Re: Interpretation for PCA 1999-HM-011, FDPA 1999-HM-011-1-2, Van Metre at Woodland Park
Tax Map 16-3 ((1)) 25D1, 25D2, 25D3; 16-4 ((1)) 32B: Building footprint, and parking modifications, elimination of a swimming pool, addition of courtyards, and relocation of dumpster

RE: Woodland Park
Land Bay C-2
PCA/FDPA 1999-HM-110-1-2
Additional Information Requested to Support
Determination Letter of August 23, 2005
VIKA #59172

RE: Van Metre at Woodland Park
Interpretation Request
PCA 1999-HM-011 and CDPA/FDPA
Hunter Mill District
Fairfax County, Virginia
VIKA #59175

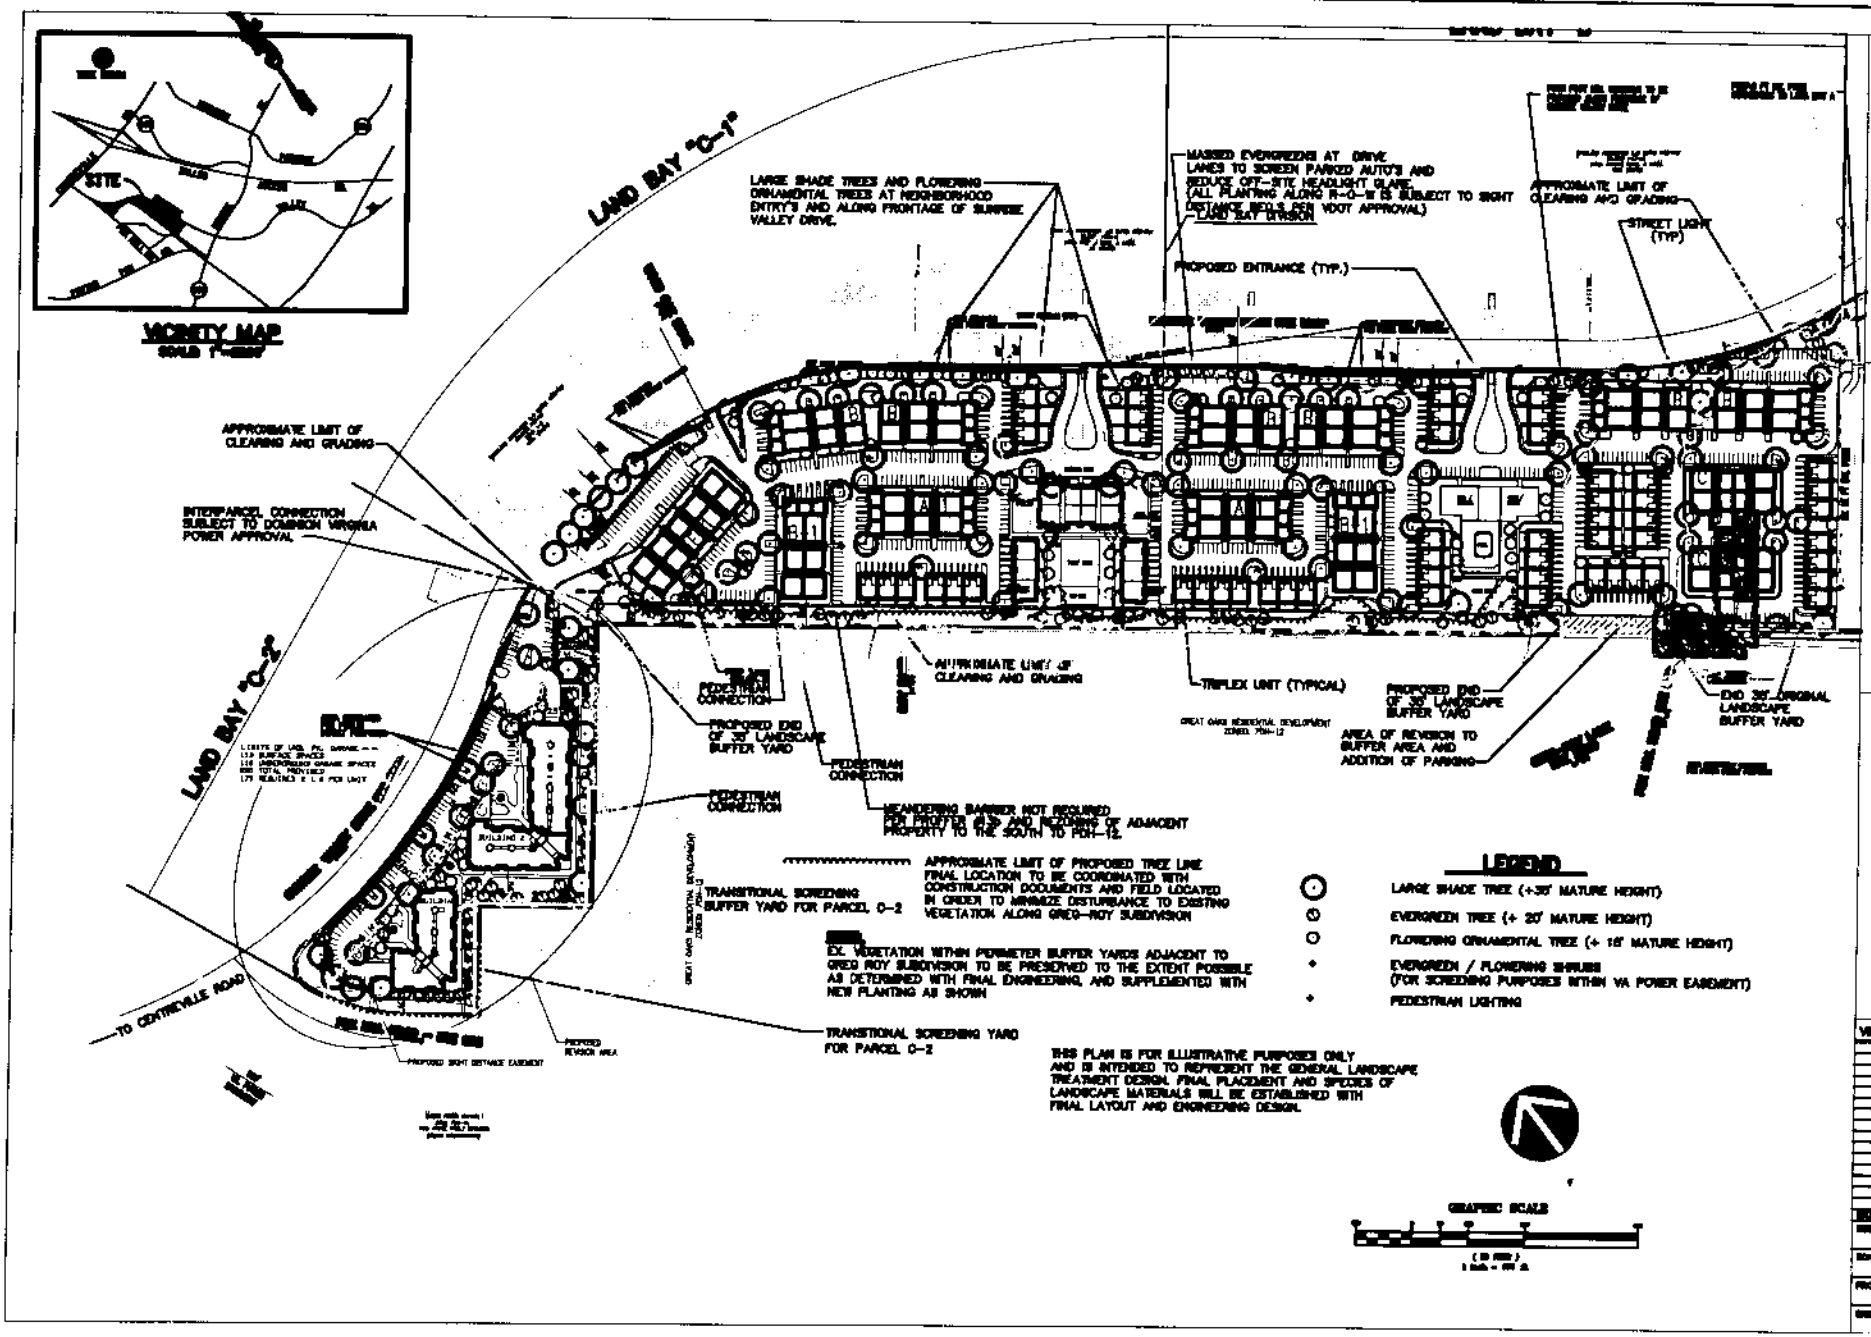
As I understand it, your first question is whether moving 112 parking spaces under the two buildings in Land Bay C-2 would be in substantial conformance with the proffers, CDPA/FDPA, and development conditions. You indicate that in order to improve the site design, parking is proposed to be provided under Buildings 1 and 2. This will allow the elimination of an equivalent number of surface parking spaces and the provision of three landscaped courtyards in front of the two buildings. Impervious surface on the site would be reduced from 36,123 square feet to 27,372 square feet. No increase in the approved building height (50 feet) is proposed. It is my determination that relocation of parking spaces under the Buildings 1 and 2 would be in substantial conformance with the proffers, CDPA/FDPA, and development conditions.

As I understand it, your second question is whether modifications to the footprints of Buildings 1 and 2 would be in substantial conformance with the proffers, CDPA/FDPA and development conditions. You are proposing to move Building 2 northward by approximately 20 feet. The footprint of Building 1 is proposed to expand northward by approximately 35 feet and southwestward by approximately 40 feet as shown on your plan. The building footprints would continue to maintain building setbacks as approved on all sides except on the south side of Building 2 where the setback would be increased from 40 feet to 66 feet. You have stated that the number of units remain as approved. You are proposing to reduce the area of Building 2 by 1,251 square feet and increase the area of Building 1 by 5,675 square feet to facilitate the design of the underground parking. It is my determination that modifications of the building footprints would be in substantial conformance with the proffers, CDPA/FDPA, and development conditions.

As I understand it, your third question is whether creation of three landscaped courtyards in front of the buildings, elimination of the swimming pool and clubhouse and relocation of the trash dumpster would be in substantial conformance with the proffers, CDPA/FDPA and development conditions. You have stated that creation of three landscaped courtyards provide an amenity for the buildings in lieu of originally proposed surface parking spaces. Three swimming pools are shown on the CDPA/FDPA; two have been built. Construction of the third swimming pool was optional per Proffer 4 which in part states, "The applicant reserves the right to construct a third swimming pool with clubhouse on the western portion of the Application Property as shown on the CDPA/FDPA. In the event the Applicant elects not to construct these facilities, the area of the swimming pool and clubhouse shall be maintained as landscaped open space, or the Applicant may elect to seek a FDPA for alternate use of the area, without requiring a proffered condition amendment." You are proposing to provide landscaped open space in lieu of the swimming pool and the club house. You are also proposing to relocate the trash dumpster inside the building. You have stated that the proposed changes would provide an overall gain of 4 percent landscaped open space. It is my determination that the proposed landscaped courtyards, elimination of the swimming pool and club house and relocation of the trash dumpster inside the buildings are in substantial conformance with the proffers, CDPA/FDPA and development conditions.
